SUBJECT: AMENDMENT NO. 129 TO FACILITY OPERATING LICENSE NO. NPF-30 -
CALLAWAY PLANT, UNIT 1 (TAC NO. MA1113)

The amendment revises the TS to allow an increase in the Callaway Plant, Unit 1 spent fuel pool storage capacity from 1344 to 2363 fuel assemblies. The amendment also revises the TS to allow storage of an additional 279 fuel assemblies in the cask loading pit.

SAFETY EVALUATION BY THE OFFICE OF NUCLEAR REACTOR REGULATION

RELATED TO AMENDMENT NO. 129 TO FACILITY OPERATING LICENSE NO. NPF-30

FIGURE 3.9-1

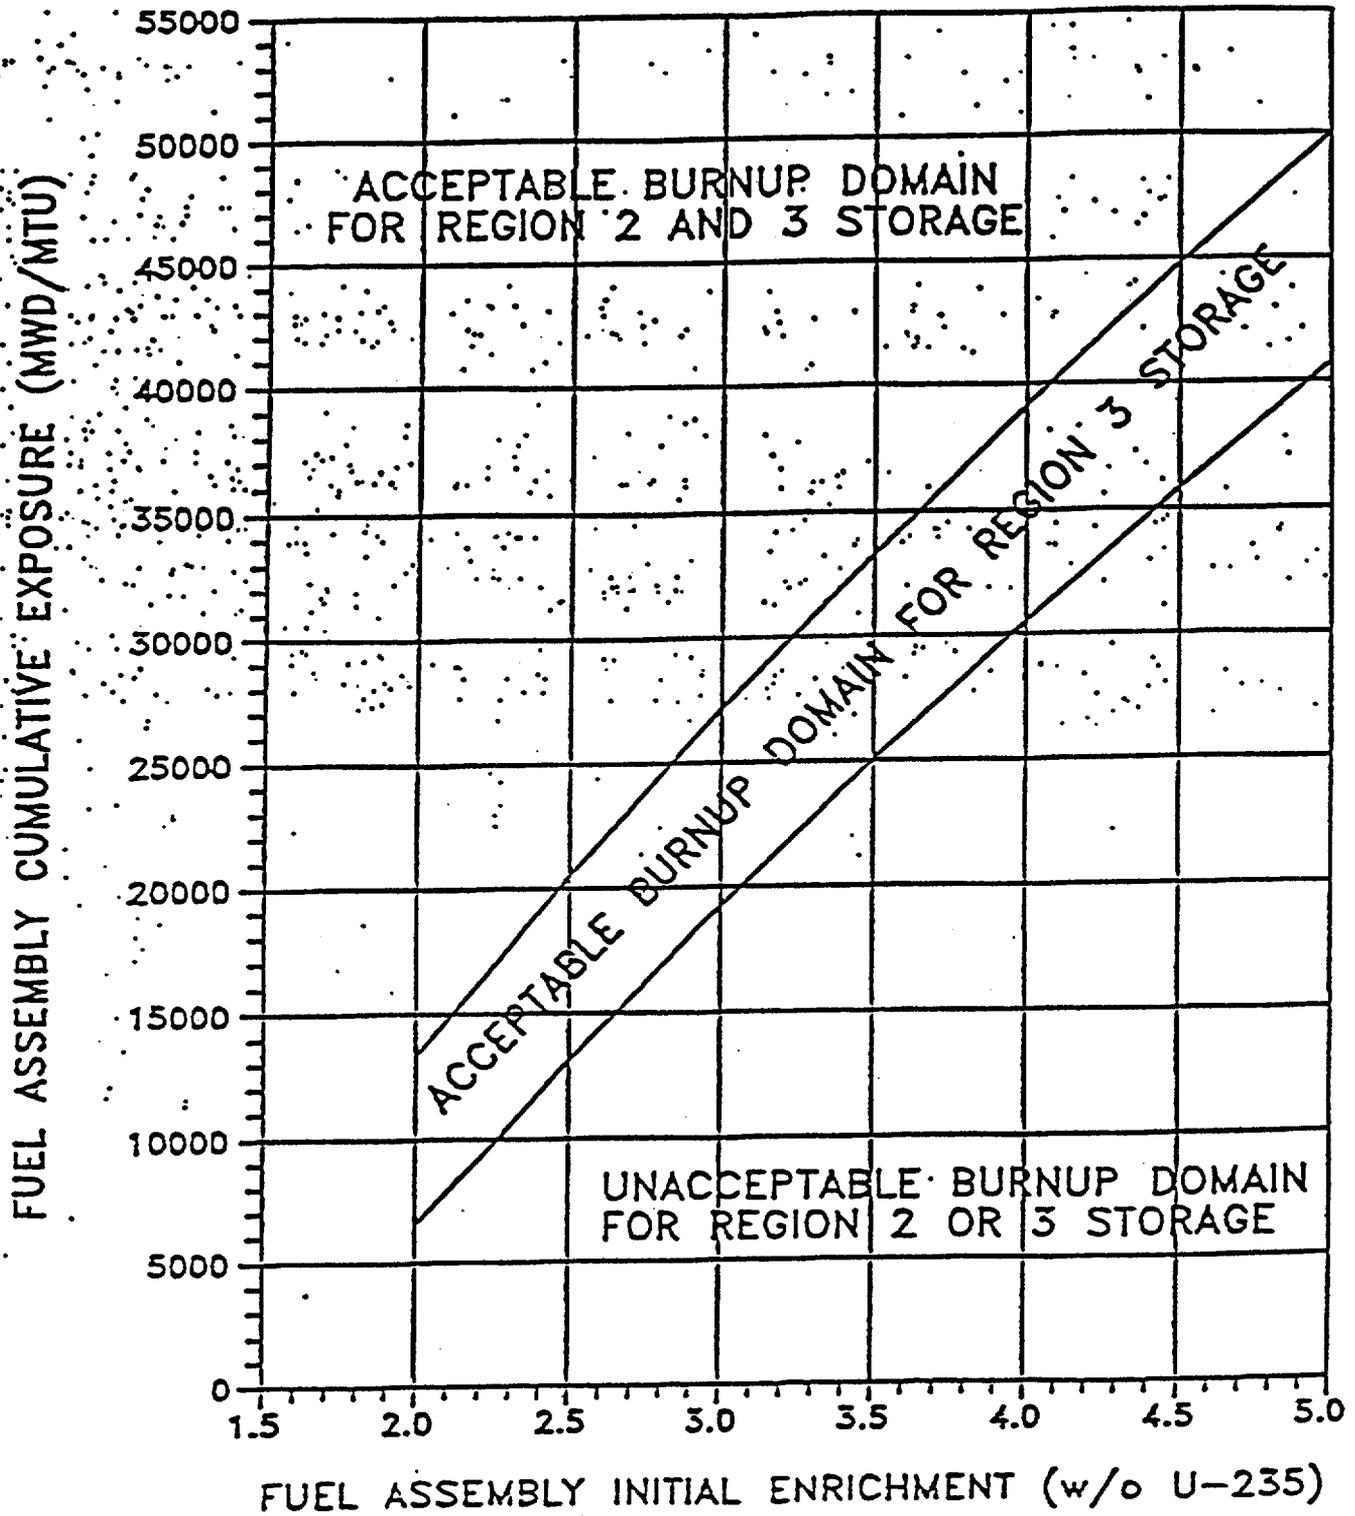
1. TS 3.9.12 has been revised to reflect the conditions required for fuel assembly storage in Regions 1, 2, and 3. The associated Figure 3.9-1, which shows the minimum required fuel assembly burnup as a function of initial enrichment for allowed storage in Regions 2 and 3, has been revised.

3. TS 5.6.1.1a has been modified to allow spent fuel storage in Region 2 and 3 based on acceptable combinations of initial enrichment and discharge exposure as shown in Figure 3.9-1.

- a. Spent fuel assemblies regardless of burnup can be placed in Region 1.
- b. Spent fuel assemblies within the burnup-enrichment range shown in Figure 3.9-1 for Region 2 fuel shall be placed in Region 2 or 3.
- c. Spent fuel assemblies within the burnup-enrichment range shown in Figure 3.9-1 for Region 3 fuel shall be placed in Region 3.
